PHILCO RADIO-PHONOGRAPH MODEL 51-1330

**MODEL 51-1330
IF 455 KC**

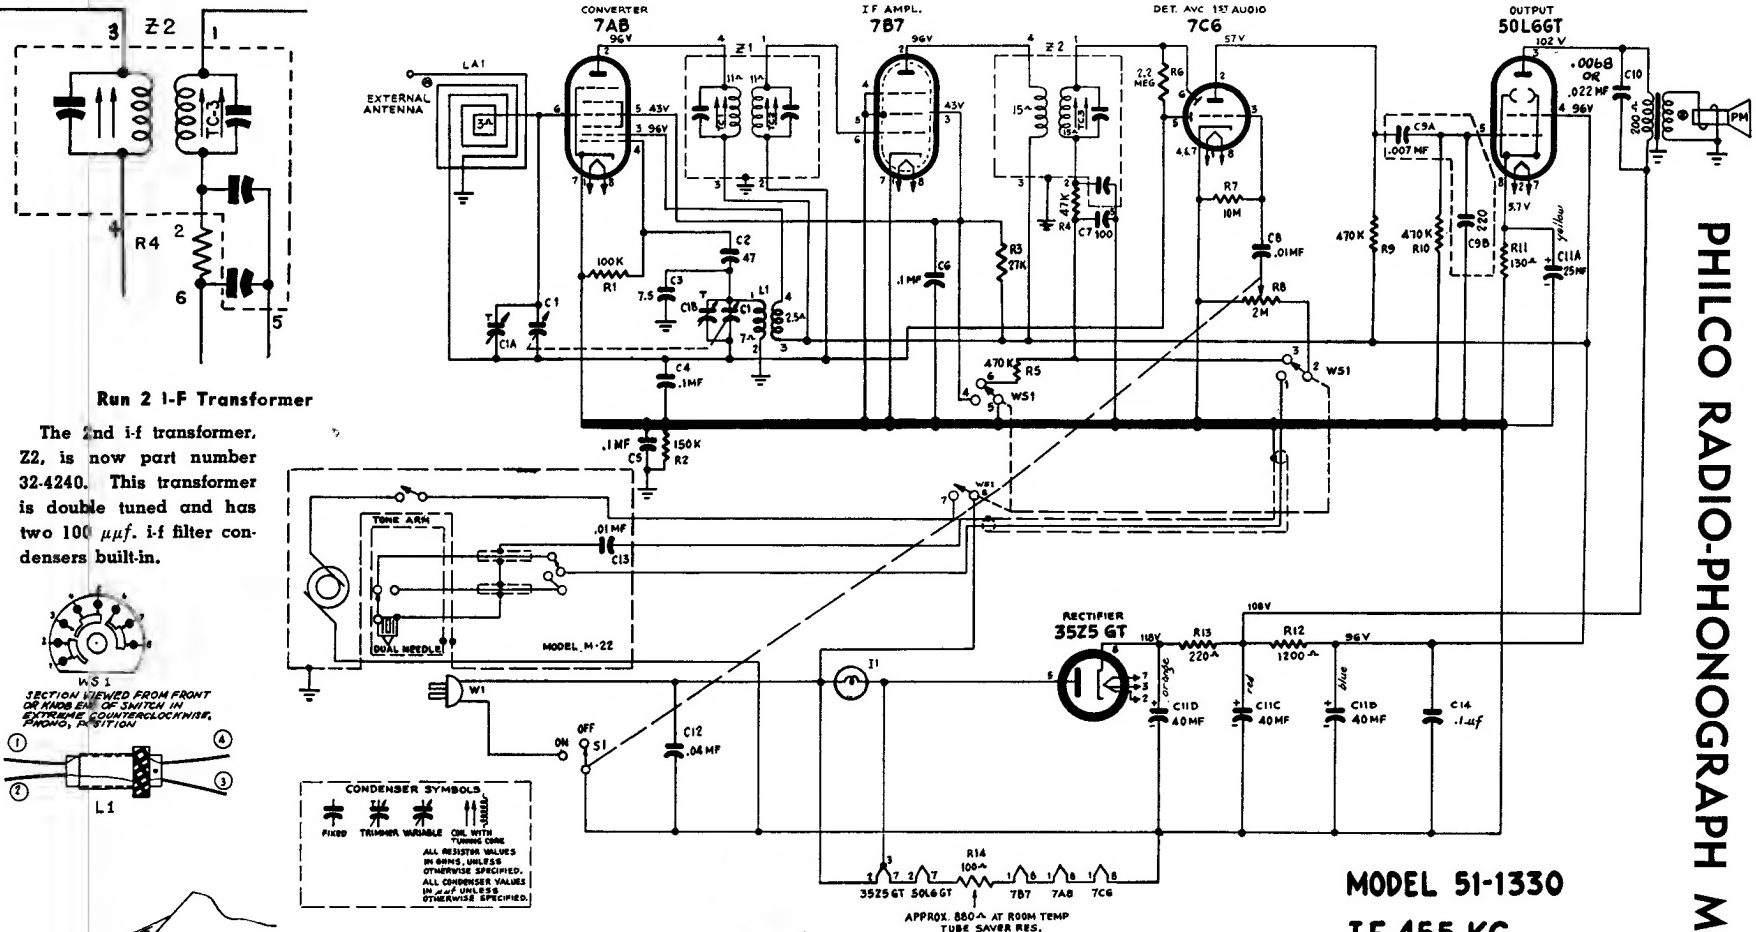
Run 2 I-F Transformer
The 2nd i-f transformer, Z2, is now part number 32-4240. This transformer is double tuned and has two 100 μ f. i-f filter condensers built-in.
